PUBLIC INTEREST REVIEW FOR GROUNDWATER APPLICATIONS

SUBJECT: Application G- 18311 Supersedes review of _____
Date of Review(s)

Applicant's Name: Christina Arapolu / John & Sandra Thorne; Easy Valley Farm LLC County: Jackson

A1. Applicant(s) seek(s) 0.15 cfs from 1 well(s) in the Rogue Basin,
Evans Creek subbasin

Stream-depletion Model Results (SW#1)

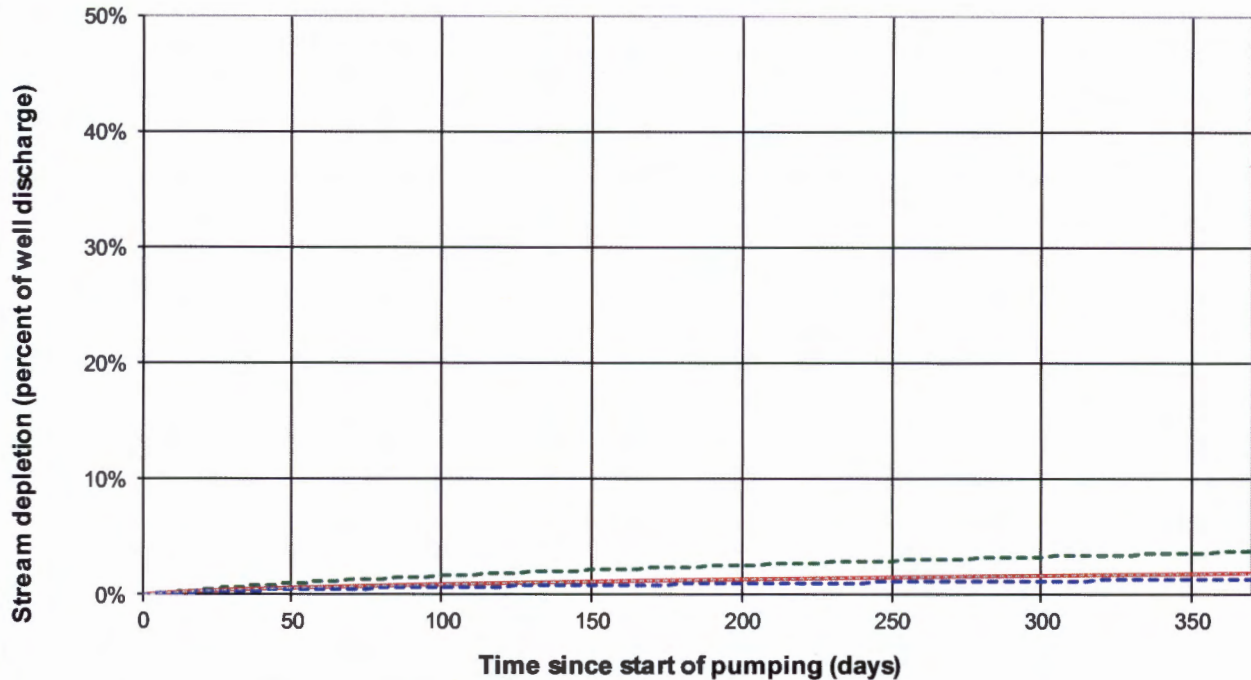
Comments: Interference @ 30d was estimated using the Hunt (1999) analytical stream-depletion model. Model results for SW #1 are attached below.

C6. **SW / GW Remarks and Conditions:** The review found that the applicant's proposed POA would be producing from an unconfined aquifer and is within 1/4 mile of Maple Creek (a mapped, intermittent stream with several permitted surface-water PODs) and within 1 mile of Evans Creek (a perennial stream with two instream water rights and many surface water PODs). The distance to Maple Creek requires the Department to assume that the use will have PSI with Maple Creek but no such assumption is required to Evans Creek. Calculated interference (i.e., stream-depletion) with both streams would be below 1% after 30 days of pumping.
